| RE: Emission Modification Notification – [[2020050027]] MY 13 E350 BlueTec Update – Emission Modification Category (EMC) #7 | DATE: May 27, 2022 |

SUBJECT: **Model E-Class diesel vehicles (W212 platform)**
Model Year 2013
Modification to the emission control system

Order No. P-EC- 2020050027

Figure 8

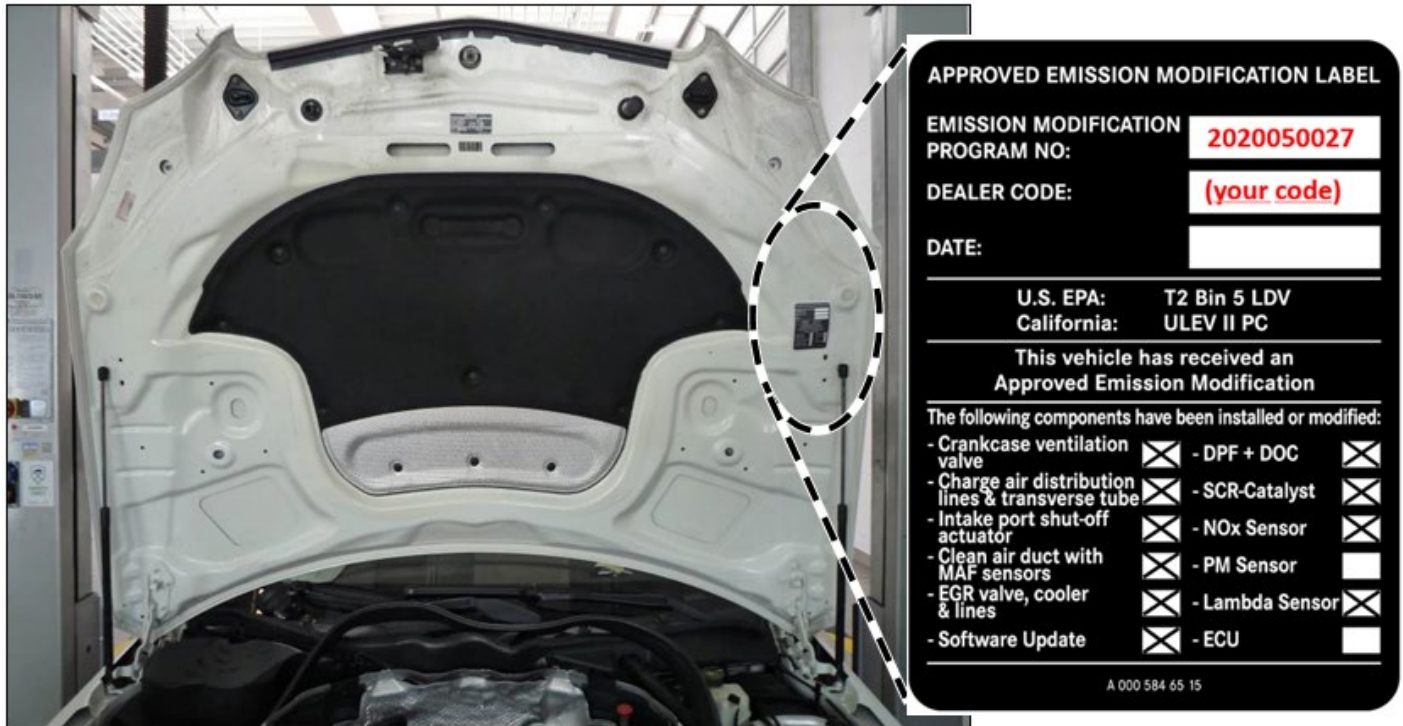
13. Clean the bonding surface area of the hood and apply the adhesive label (A 000 584 65 15) (Figure 8).

i The fields on the label must be filled in accordingly. Please use black permanent marker. Refer to XENTRY procedure.
